**Marion County
Board of County Commissioners**

**PLANNING & ZONING SECTION
STAFF REPORT**

Hearing Dates	P&Z: 07/28/2025	BCC: 08/19/2025
Case Number:	250802SU	
CDP-AR:	32795	
Type of Case:	Special Use Permit: Outdoor storage of RVs, boats, trailers, and any ancillary use for vehicle storage	
Owner	Partners Self Storage, LLC	
Applicant	Klein & Klein, PLLC; Ethan A. White ESQ. (Agent)	
Street Address	7655 E Hwy 25 Bellevue, FL 34420	
Parcel Number	39169-000-00 & 39169-003-00	
Property Size	±11.00 acres	
Future Land Use	Commercial (COM)	
Zoning Classification	Community Business (B-2)	
Overlay Zone/Scenic Area	Secondary Springs Protection Zone, Urban Growth Boundary; City of Bellevue Utility Service Area	
Staff Recommendation	Approval with Conditions	
P&ZC Recommendation	Approval with Conditions (5-0); Considered Individually	
Project Planner	Erik Kramer	
Related Case(s)	[1] APPROVED March 2025: Ord. 25-04 / Case 25-S03 for a Small-Scale Land Use Amendment from MR to COM [2] APPROVED August 1987: Case 87R-289Z for a Zoning Change from R-1, R-4, & A-1 to B-2 [3] DENIED August 2008: Case 080113V for a variance to reduce spacing requirements for two (2) billboards.

Figure 8

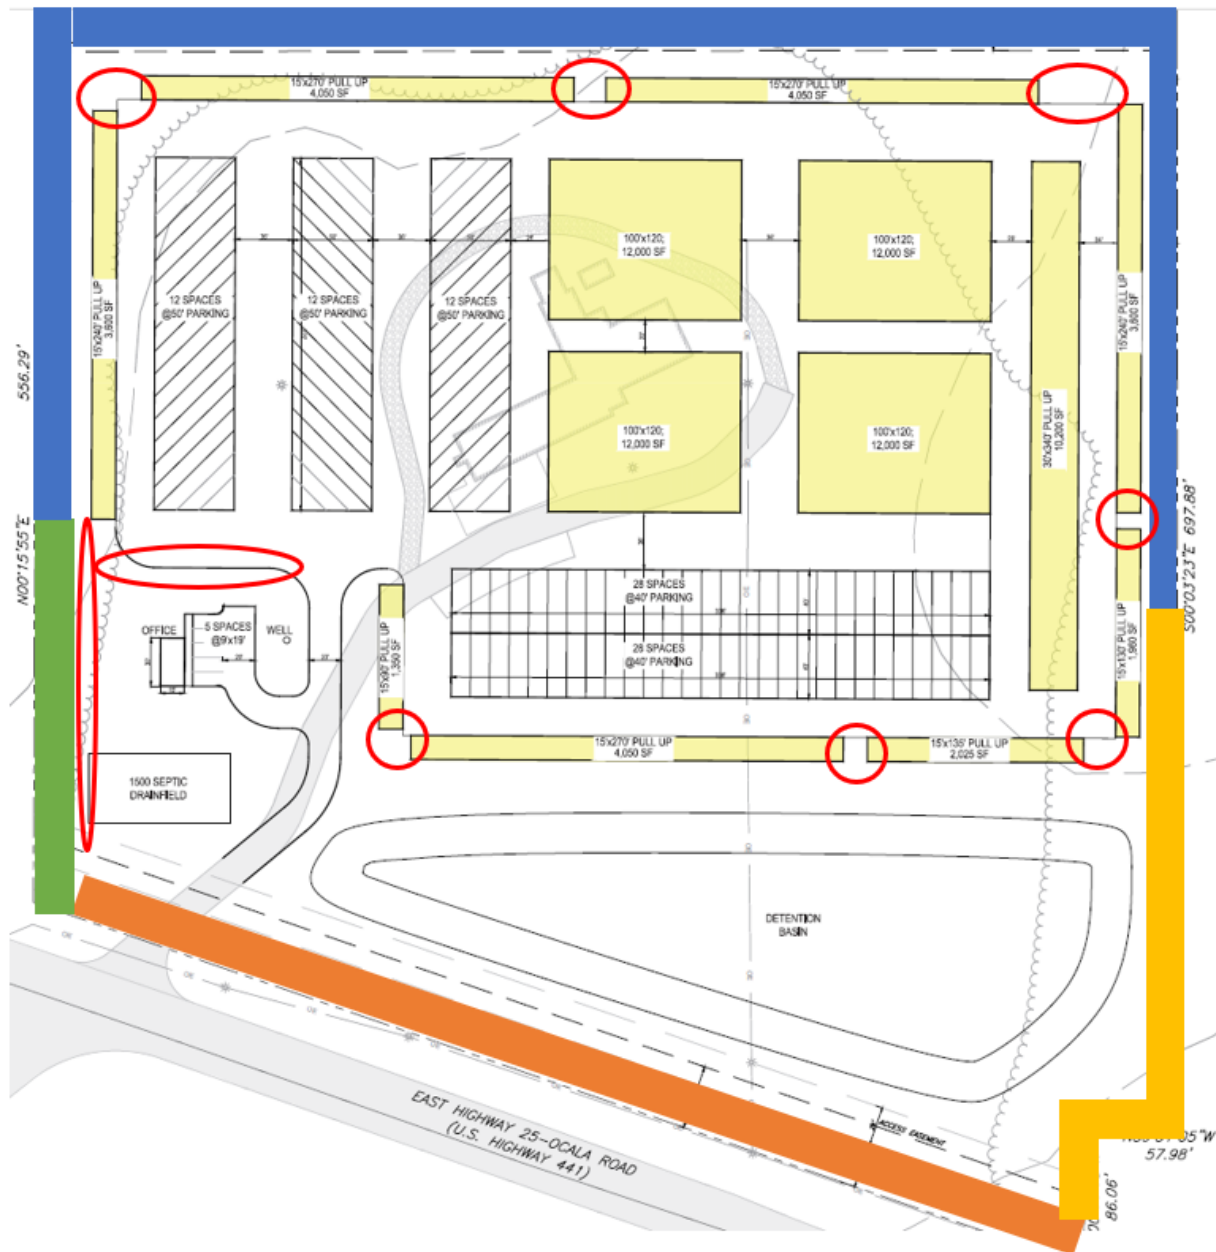
Regarding buffering, the conceptual plan shows a 20-foot Type B buffer along the west and north property boundaries which host residential uses. A 20-foot Type B buffer is consistent with LDC requirements. If the back-side of the pull-up storage walls facing the adjacent properties do not have windows, staff supports using the building walls to satisfy the Type B buffer wall requirement. In the event there are gaps between the building walls, an opaque vinyl privacy fencing, at least 6-feet in height, shall also be provided in the gaps areas to create the effect of a continuous buffer wall and screen.

The Conceptual Plan calls out a 10-foot Type D buffer along the eastern property boundary, presumably based on the adjacent property's General Agriculture (A-1) zoning. When there is an existing use, buffers are based on the existing use instead of zoning. One of the adjacent eastern parcels is classified as multi-family residential and the other parcel is classified as utility, see Figure 4. Therefore, based on LDC Sec. 6.8.6.K, a combination of a 20-foot Type B buffer along the residential use and 15-foot Type C buffer are required along the public (utility) use. In the conditions below, staff proposes an alternative buffer to use existing trees for the eastern property boundary.

The conceptual plan does not indicate the required Type C buffer along the E Hwy 25 right-of-way and does not indicate a buffer along a portion of the Duke Energy Center property. These omitted buffers are addressed in Staff's conditions below.

Figure 8 provides a visual of where these buffers would be located based on the Conceptual Plan.

Regarding screens, the Conceptual Plan (dated March 2025) does not indicate that a continuous eight (8) foot tall opaque screen – as required by the LDC – will surround the parking areas. If the pull-up storage units facing adjacent properties and streets do not have windows and they are at least 8' tall, then the storage unit walls can be used as screening. However, Figure 8 shows where there are gaps in the screening. Growth Services expects those gaps to be addressed during development review by providing a continuous storage unit wall or supplementing the gaps with an opaque vinyl privacy fencing, at least 6-feet in height. Staff supports reducing the typical height requirement of an 8-foot screen down to a 6-foot screen, contingent on preserving and using existing vegetation for the site's buffers.

- Landscape area buffers shall be provided and maintained along the site's boundaries consistent with the following:
 - North, East, and West, where pull-up / self-storage buildings are located and abut existing residential properties – a modified 20' B-Type no-touch buffer. The blank rear-wall of the storage building(s) and fencing outlined in condition 3.a shall serve as the required buffer wall. The storage buildings and fences shall be located on the perimeter of the development area with the outdoor storage being internal to the storage buildings. Viable existing buffer vegetation, as confirmed by a Landscape Architect or Certified Arborist, shall be left in place and each viable tree's Critical Root Zone shall be adequately protected during site grading and development. Any gaps in existing buffer vegetation that do not meet B-Type buffer LDC requirements shall be planted per code.

- West, where pull-up / self-storage buildings are not located and where there is an adjacent existing residential property – a modified 20' B-type no-touch buffer. There shall be an opaque vinyl privacy fence reaching at least 6-feet in height running parallel with the preserved trees. Viable existing buffer vegetation, as confirmed by a Landscape Architect or Certified Arborist, shall be left in place and each viable tree's Critical Root Zone shall be adequately protected during site grading and development. Any gaps in existing buffer vegetation that do not meet B-Type buffer LDC requirements shall be planted per code.

- East, where pull-up / self-storage buildings are not located and where there is an adjacent public use – a 20' no-touch buffer. Viable existing buffer vegetation, as confirmed by a Landscape Architect or Certified Arborist, shall be left in place and each viable tree's Critical Root Zone shall be adequately protected during site grading and development. Any gaps in existing buffer vegetation shall be planted and maintained according to the LDC.

- South, along E Hwy 25 – a 15' C-Type buffer, per LDC requirements.
- No trees shall be removed from the property prior to obtaining Development Review Committee site plan approval.
